BUREAU OF MINES

In fulfillment of the Interagency Agreement between our respective government organizations, attached is Task 1: Bureau of Mines Review of Department of Energy Report "Exploratory Shaft Design Basis Study Review."

Task 1: Bureau of Mines Review of Department of Energy Report  
"Exploratory Shaft Design Basis Study Review"

Page 59

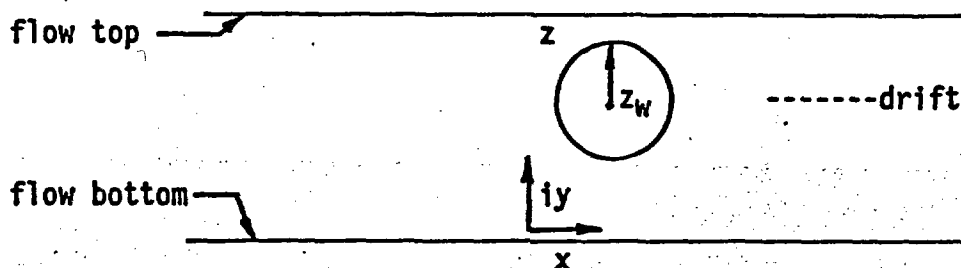
The reference given for the steady-state inflow equation on page 59 of the report is obscure, and the solution presented may be unfamiliar to many of the readers. Unlike the other conceptual models presented subsequently, it is much more difficult for the reader to verify that the equation is correct, and that the boundary conditions imposed on this solution are appropriate to the current problem. I think it is especially important therefore that the assumptions presented for this model be formalized as hydrologic boundary conditions. It would also be helpful to include a few sentences describing how the solution is derived, or at least an additional reference source.

I was able to find an analytic solution to the same problem, derived using a conformal mapping technique involving Schwartz-Christoffel transformations. The solution is in a book entitled, "Groundwater Mechanics" by Otto D.L. Strack, Prentice Hall 1987, pages 350-352. Since I have the book in manuscript form, I am not sure if these page numbers are still correct; however, it is in a section entitled, "Applications of Conformal Mapping." The expression (on the next page) is developed as an exact solution for flow to a well that is located midway between two infinitely long, parallel, constant head boundaries.

This solution is more general than the one presented in your report and would permit specification of the drift at different elevations relative to the interflow boundaries. It can also be modified to permit a difference in head boundary conditions above and below the drift, or a uniform ground water flow gradient through the flow interior. (You indicated earlier that there was an upward vertical flow gradient). If you assume the drift (well) is located exactly midway between the two boundaries, I have verified that this solution reduces to the one presented on page 59 of the report.

Along the same line, I think it is worth noting that if you solve this flow problem with a slightly simpler boundary condition, you get almost the same result. On the next page I solved the inflow problem using your numbers for the pre-connect phase of inflow, and a much simpler analytic solution for a very large diameter well. The only difference in boundary conditions between the two solutions is that the simpler expression assumes a radial, constant head boundary a distance  $d/2$  away from the center of the well, instead of two parallel boundaries a distance  $d/2$  away from the well. As you can see by comparing these numbers to those in table 4.2 of brief 0617, the difference in inflow is insignificant, given the specified parameter values.

There is a typo in the expression for  $sv$ . The inverse hyperbolic tangent function should be written as  $\text{arctanh}[x]$ ... Also in this expression,  $rw$  is drift radius (assumed to be circular), not drift width.

Since the first two assumptions regarding the use of this model are important hydrologic boundary conditions, I think they should be stated explicitly (at least parenthetically) below each assumption:
